REQUEST

Current Zoning: N1-A (Neighborhood 1-A)
Proposed Zoning: N2-A(CD) (Neighborhood 2-A, Conditional)

SUMMARY OF PETITION

**STAFF
RECOMMENDATION**

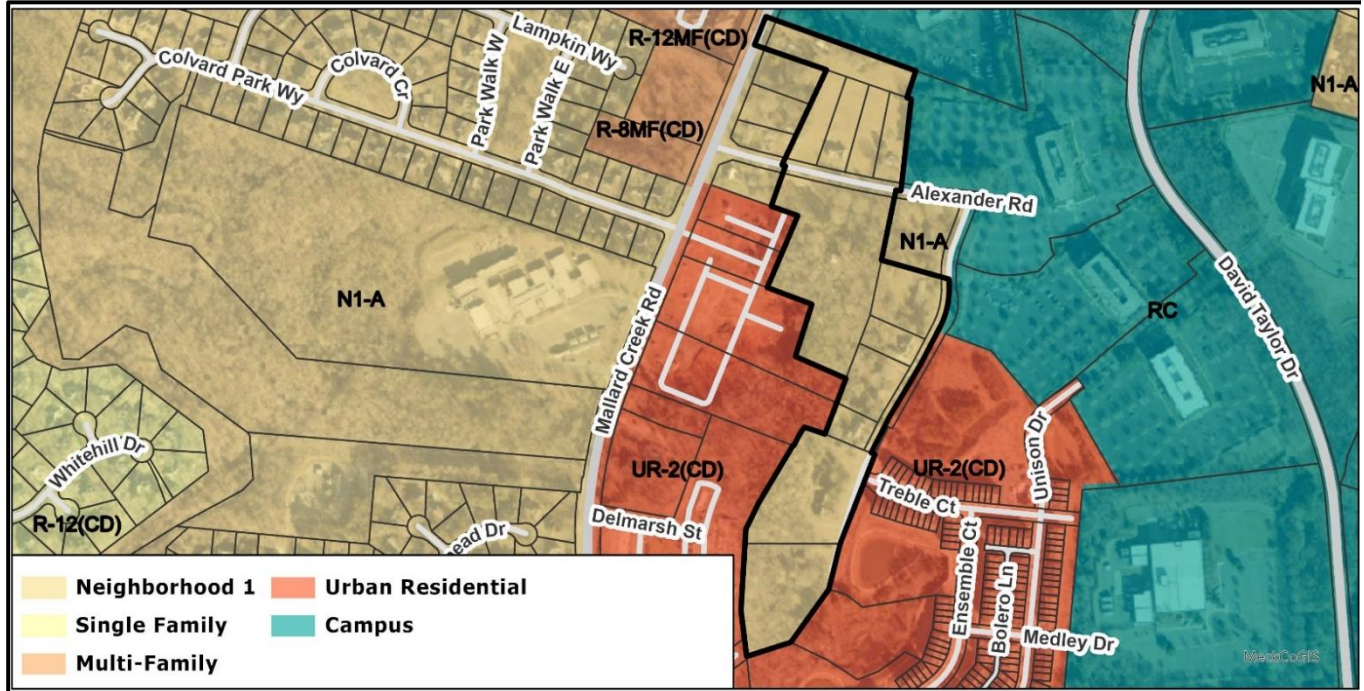
1. Revise roadway callouts to be U-03 and not U-03A1. U-03A1 is simply one part of the overall layout of U-03 while U-03 describes all of the U-03 cross sections required for this site.

2. Revise roadway callouts to be U-03 and not U-03A1. U-03A1 is simply one part of the overall layout of U-03 while U-03 describes all of the U-03 cross sections required for this site.

3. Add proposed ROW dimensions to the site plan for College View Lane and Alexander Road. Ensure ROW is dimensioned in relation to the roadway centerline.

4. Revise site plan by revising callout to say final design of Treble Court connection to College View Lane to be coordinated during permitting.
5. Revise roadway identifier on the site plan to callout roadway as proposed, due to this not currently existing.

6. The existing R/W does not exist connecting to Silver Branch road. Label that the R/W and street will be constructed and improved along the entire project boundary.

7. Label the 8' sidewalk and 8' planting strip on all public streets. Label the centerline and the distance from centerline to 2' behind the sidewalk as R/W.

8. Ensure that tree save meets all standard. Tree save has a 10' no build zone around it and does not permit sidewalks within tree save.
9. Some areas shown as tree save do not have any trees. Adjust tree save areas to include existing canopy.

10. Clarify the provided seating requirements for public open space.
